IT Secondary Cabling Conduit Connector Security Seal Requirements

Revenue Metering Subcommittee Meeting

August 26, 2005

IT Secondary Cable Conduit Connector Issues

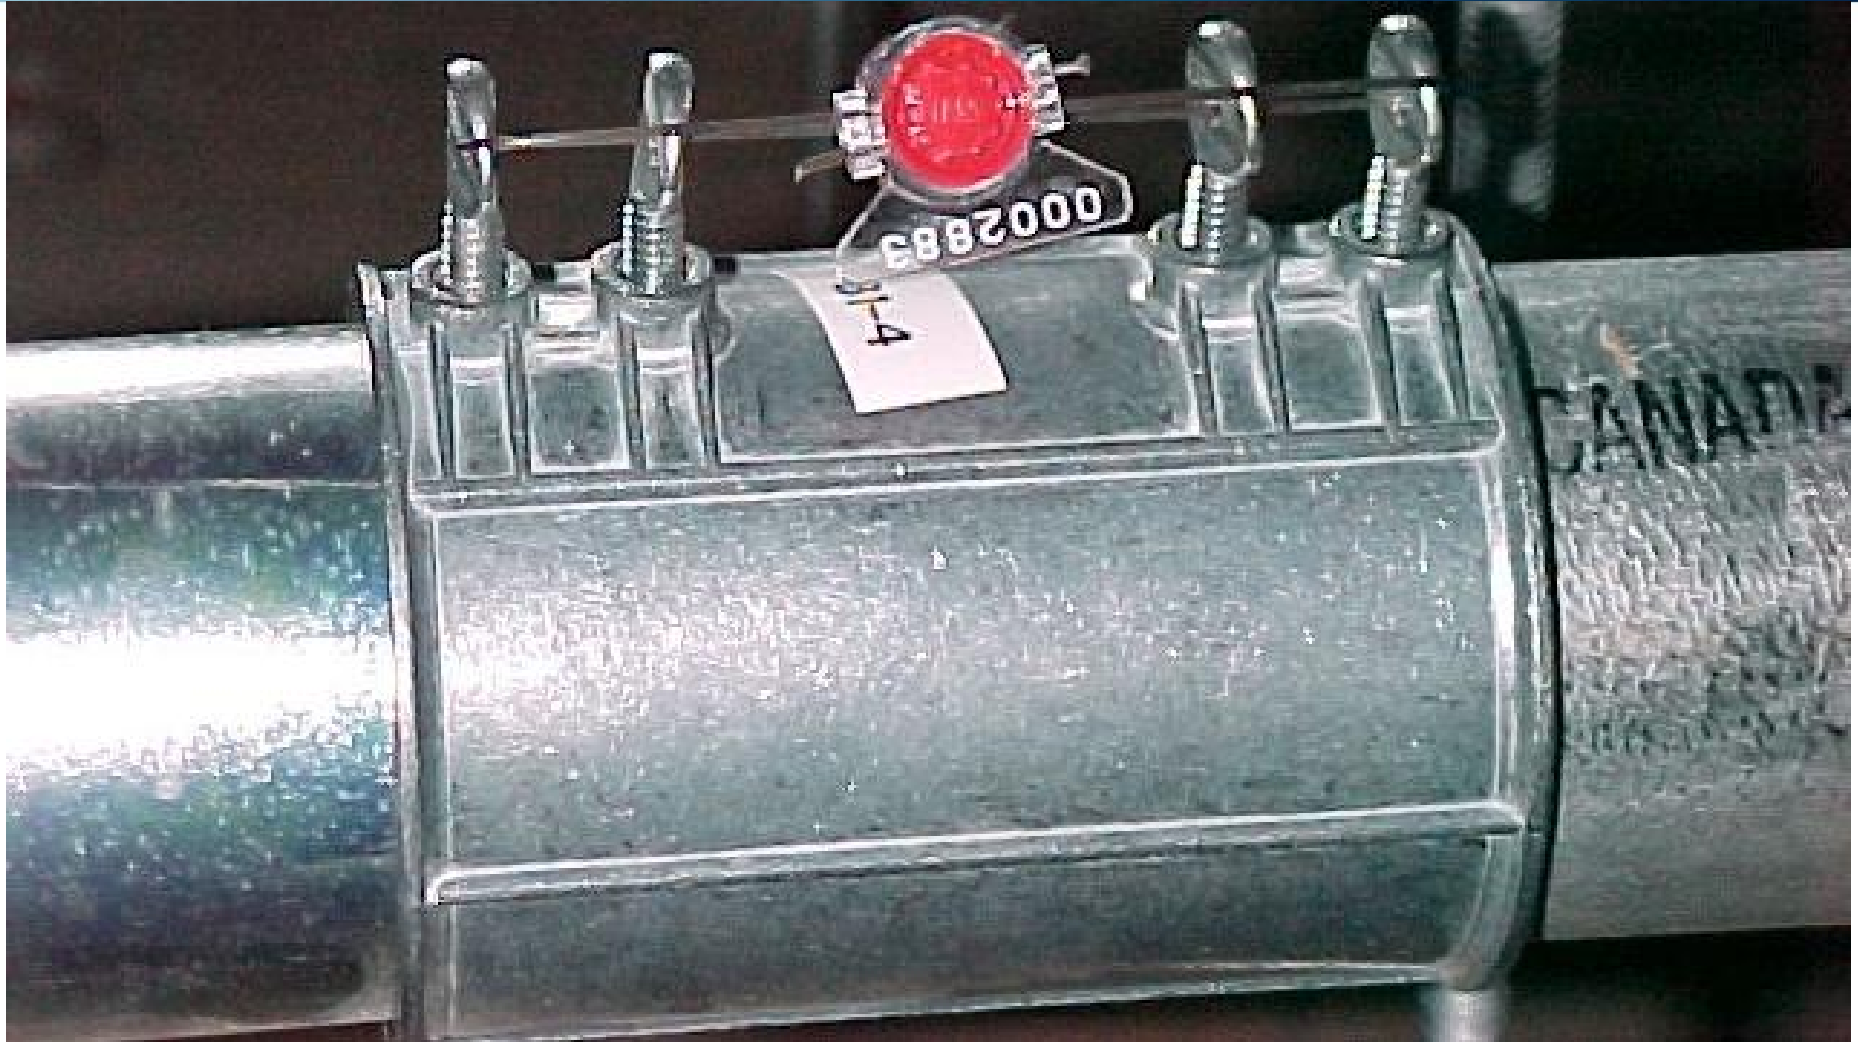
- q PVC conduit sections can be welded to prevent access to IT secondary cables**
- q EMT conduit has mechanical connectors that allow access using hand tools**
- q To date, IESO staff have required MSPs to install security seals on “all IT secondary cabling access points” – including metallic mechanical conduit connectors**

Proposal to Disable Access Point at EMT Conduit Connector

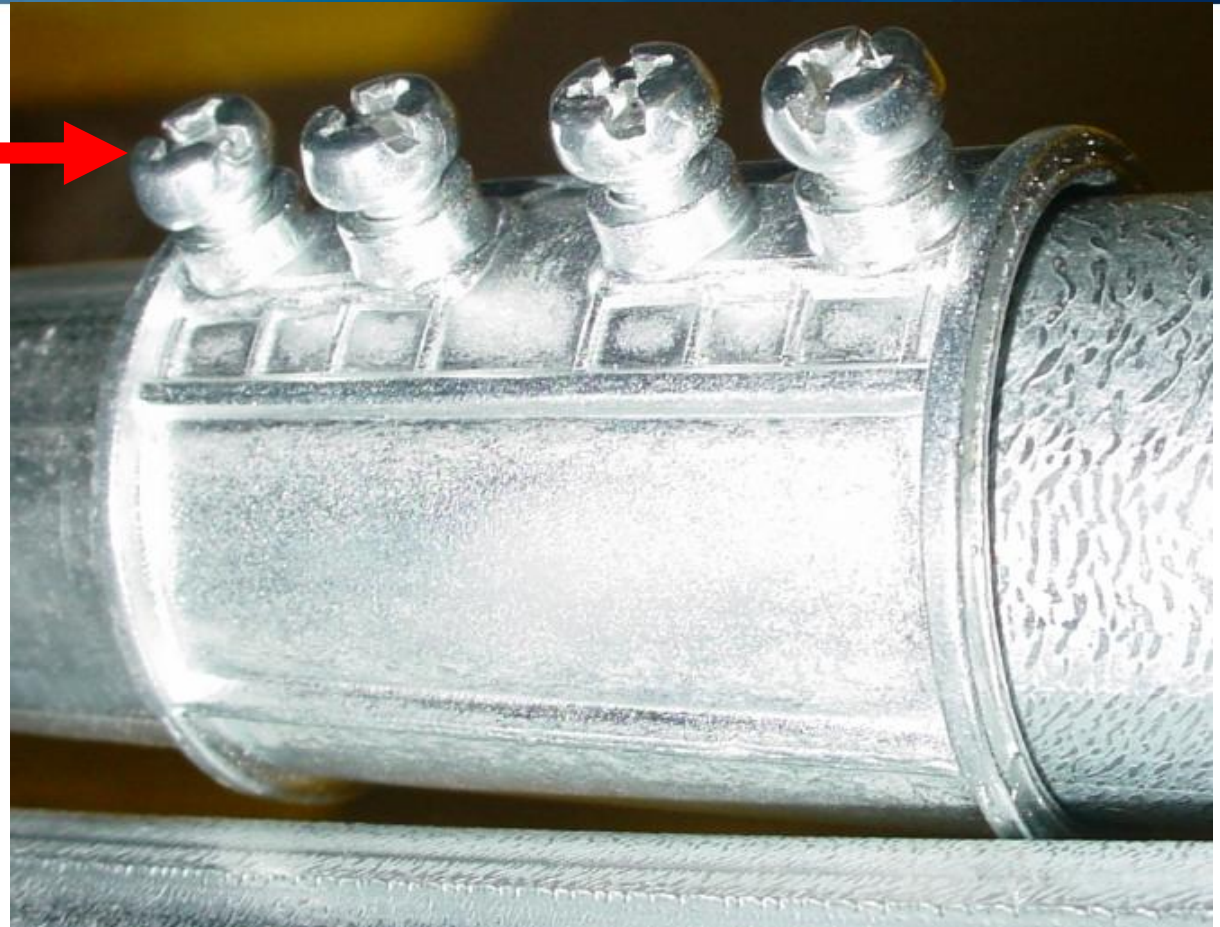
- q After the EMT conduit system is assembled, the MSP tightens all set screws at the EMT connector and saws off the screws to prevent future access**

- q If accepted, this proposal would eliminate the need to install a security seal on any EMT connector that has been permanently disabled by the MSP**

**Tighten set screw
connectors, then
cut off screw
heads flush with
connector base to
prevent future
access to IT
secondary cables.**

q IESO staff support this proposal:

- Consistency with security requirements for PVC conduit connectors
- Eliminates a conduit “access point” – thus no security seal required
- Reduces long term costs for both MSP and MMP
